M & R HOSIER COMMENTS ON 8.18 - APPLICANT'S COMMENTS ON WRITTEN REPRESENTATION
SUBMITTED BY M & R HOSIER

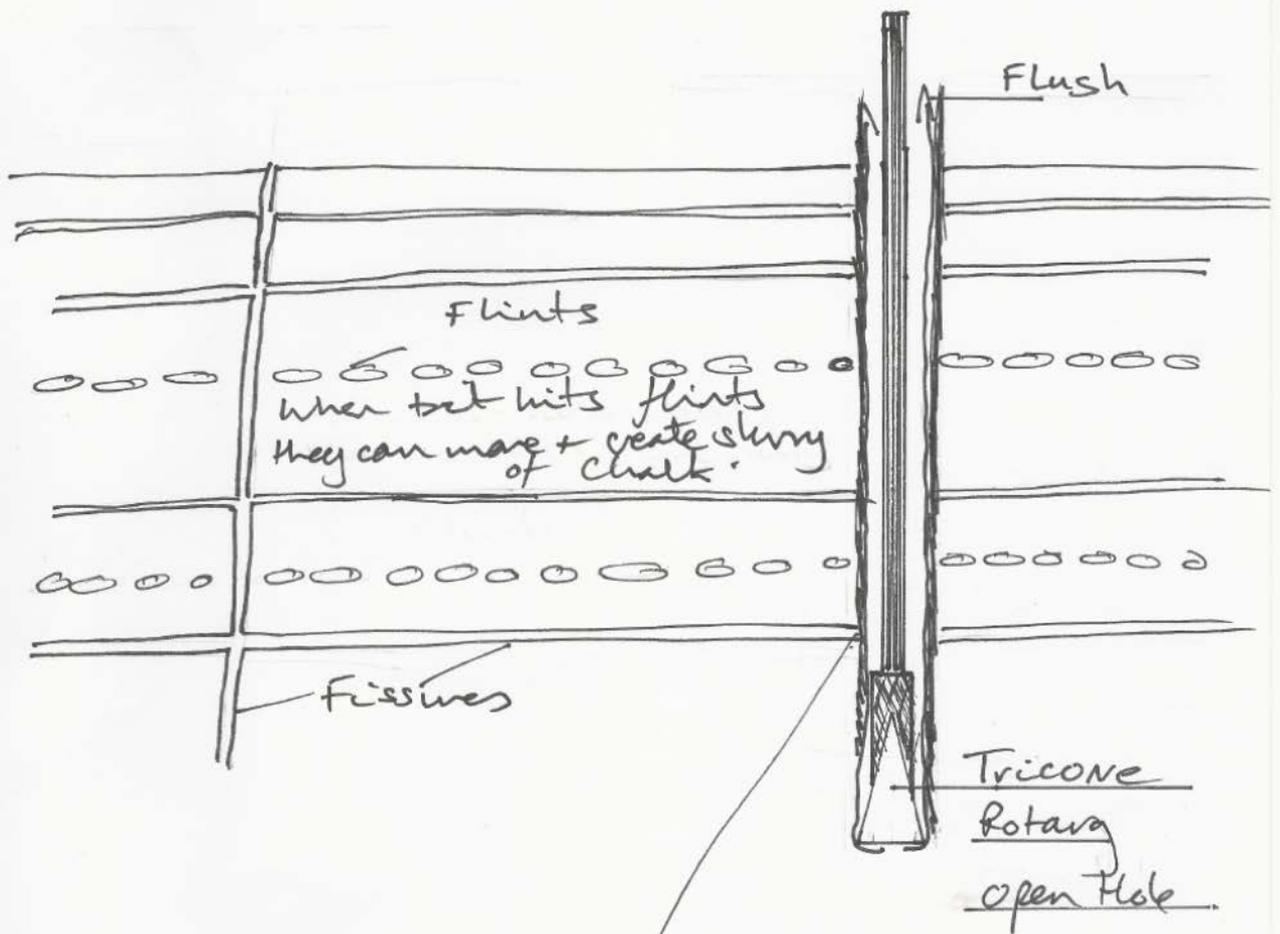
4. The Computer model uses a grid of 250m. A 5mm fissure is $0.005/250 = 1/50,000$. Modelling is accurate to at most 10%. If we divide the block into 50,000 slices with 49,999 having a permeability of 1 we can calculate what the 1/50000th has to equal to increase average by 10%.

Therefore a fissure 0.005m thick could have a coefficient of permeability 5001 times the other 49,999 slices and it would only increase the value of the 250m block by 10% which is within HE margin of error. Therefore the model may be correct and still ignore fissure flow.

Sketch showing mud cake from drilling in filling fissures + reducing permeability. Mud cake can be 2-3mm thick, so can block fissures of this width.

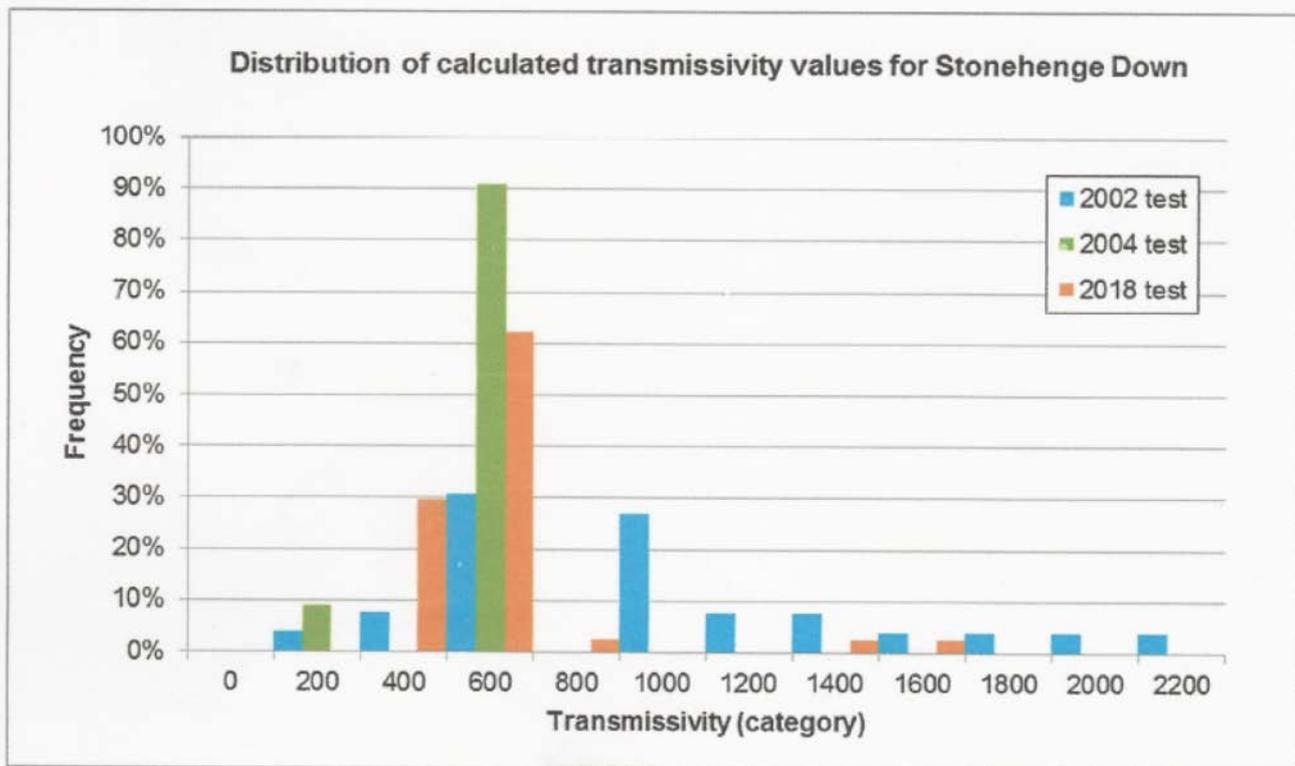
6. The pumping tests undertaken by WJ Engineering and Structural Soils were undertaken in boreholes which were not acidized. WJ used a cable percussion rig and Structural Soils used a tricone rotary bit –open hole. Drilling smears the Chalk, producing a mud cake lines the walls of the borehole which infills the fissures. Eductors can remove some of the mud cake but to be reliable acidisation should be undertaken, as recommended by the late Dr Richard Monkhouse of the British Geological Survey. Rotary open hole methods produces a far thicker mud cake than cable percussion methods as the drilling flush is blown against the walls of the borehole and into the fissures- see Figure 1 . Figure 2 figure 6.16 from S A P test 2018 Inter'Report) below shows that the boreholes drilled by SRK produced lower Transmissivities than WJ Engineering when comparing summer results. Therefore there may be fissures present whose entrance in the borehole wall have been completely or partially closed by mudcake.

Fissures can be up to 5mm wide or even greater
